# 2020 Corvette: Service Bulletin: #N202302840: Service Update - Door Paint Chipping

**Subject:** N202302840 — Door  
Paint Chipping  
**Models:** 2020 Chevrolet Corvette

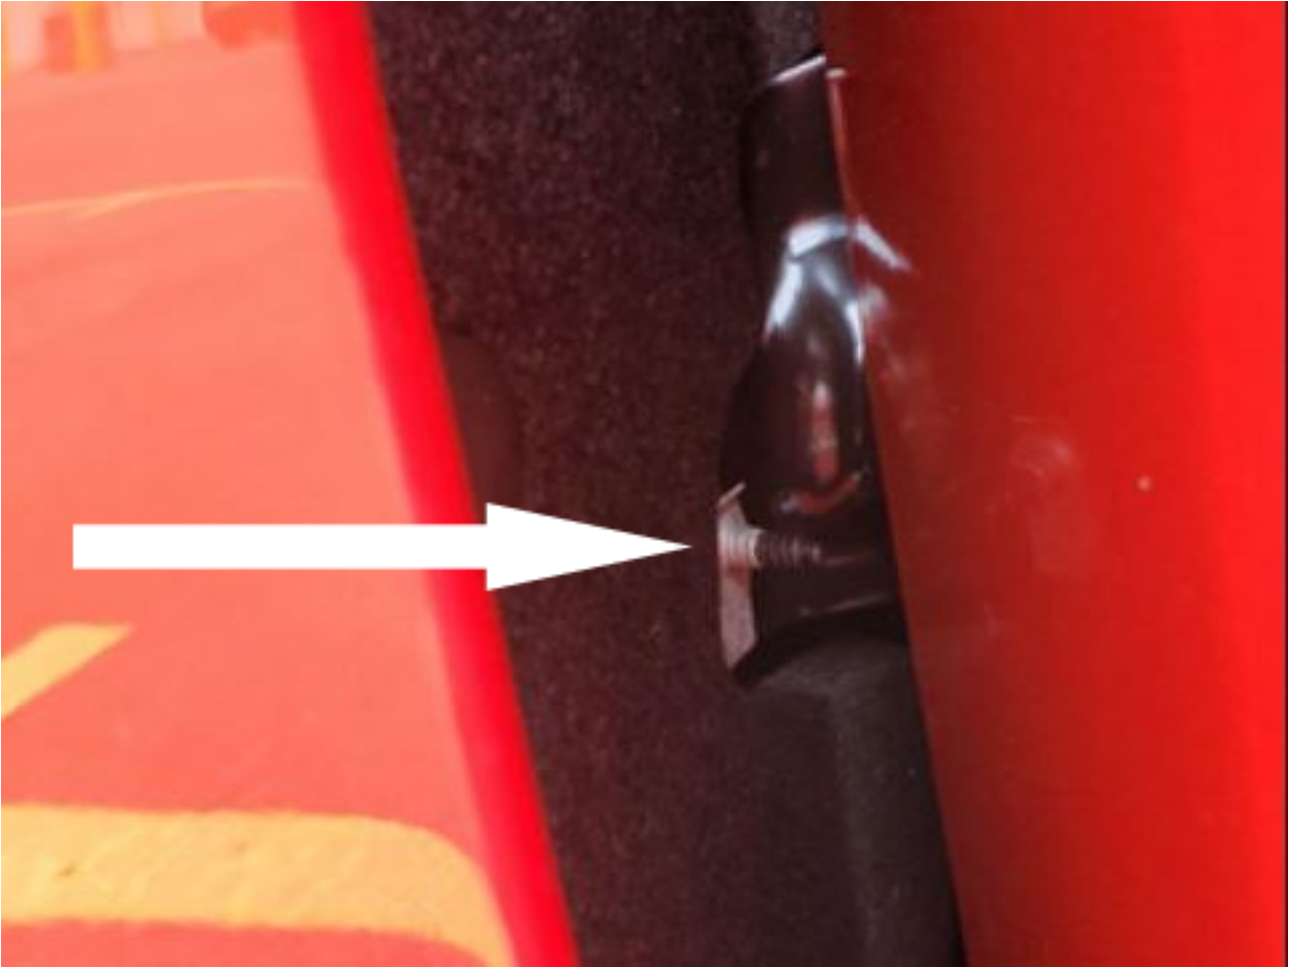
1. Carefully open the left front door inspecting for any contact with the fender fastener. This fastener is located just below the door check strap area.
2. Locate the threaded portion of the fender mounting bolt where

it exits the nut.

3. Count the number of threads showing.

- If less than 1 full thread is showing, no further action is required.

- If more than 2 threads are showing, proceed to step # 4.
- Partially remove the wheelhouse liner to access the rear fender mounting fasteners. Refer to *Front Wheelhouse Liner Replacement* in SI.
  1. Locate and remove the center fender to body fastener as shown.
  2. Install the shorter service fastener. Tighten  $9\text{ Nm}$  ( $80\text{ lb in}$ ).
  3. Reinstall the wheelhouse liner. Refer to *Front Wheelhouse Liner Replacement* in SI.
  4. Repeat steps 1-7 on the right side of the vehicle.
